Evaluation Kit for RA2L1 Microcontroller Group
EK-RA2L1 v1
Errata

Renesas RA Family
RA2 Series

EK-RA2L1 v1

Figure 1. Breakout Pin Headers J1, J2, J3, J4

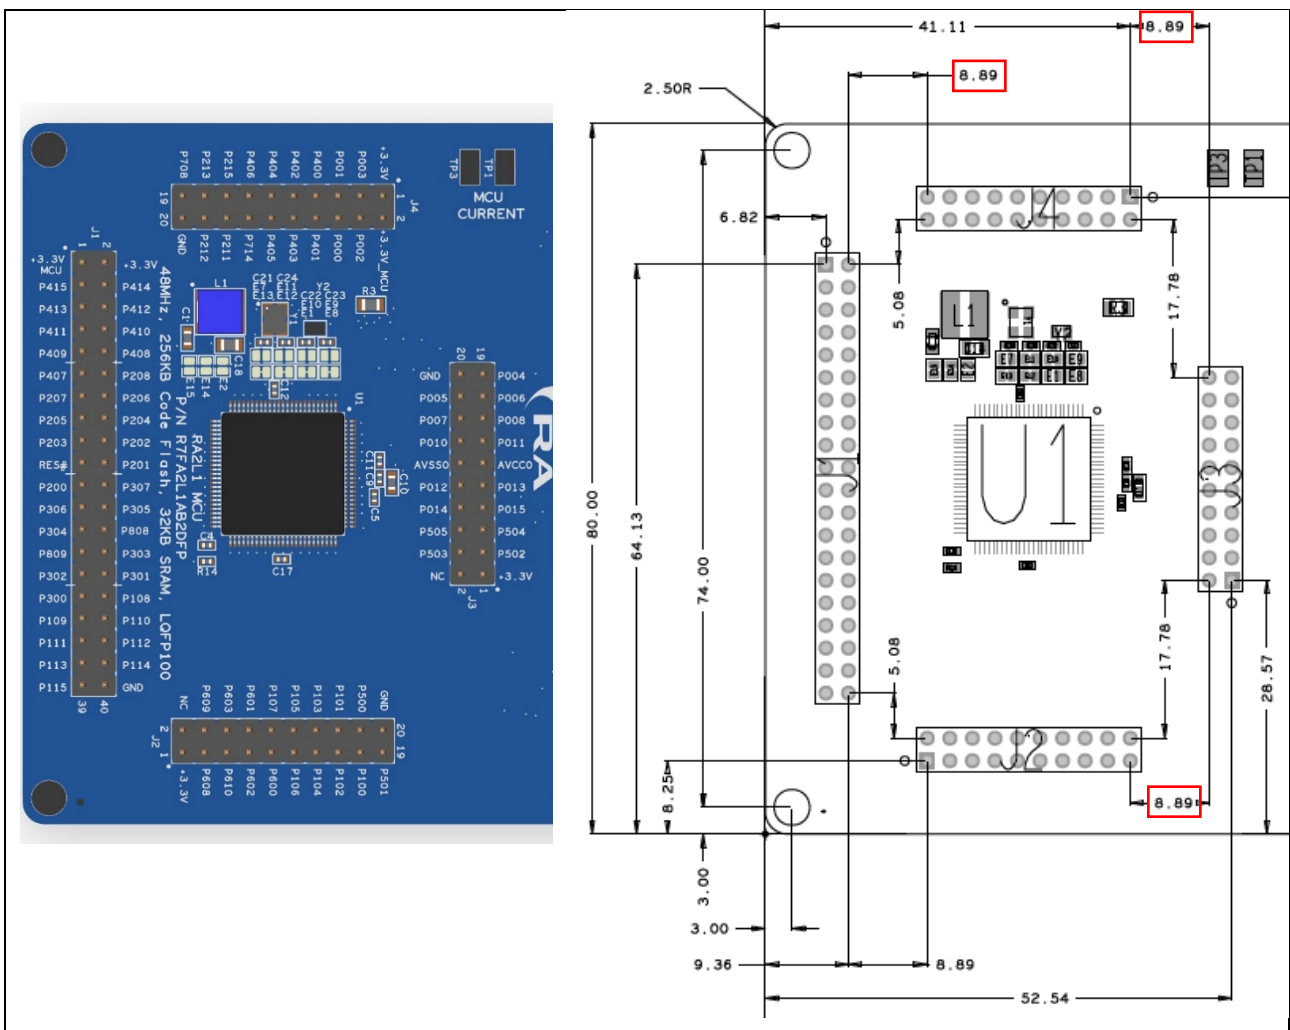
The breakout pin headers J1, J2, J3, and J4 on the EK-RA2L1 board should align to a 0.1" grid to enable the easy placement of any compatible piggyback board.

With reference to the dimensional drawing, it can be seen that J2 and J4 are not aligned to the grid along one axis.

None. The breakout pin headers have been moved to align with the 0.1" grid on later builds of the board.

Figure 3. Breakout Pin Header J4

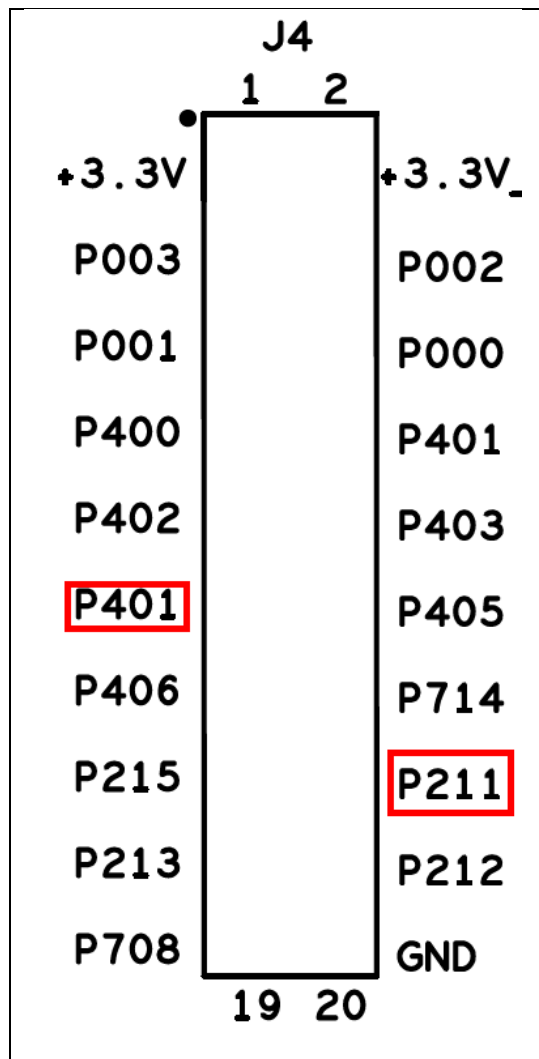
The silkscreen for the breakout pin header J4 on the EK-RA2L1 board has two pins which are mislabeled. J4-11 (P404 is mislabeled as P401) and J4-16 (P214 is mislabeled as P211).

None. The breakout pin header J4 silkscreen has been corrected on later builds of the board.
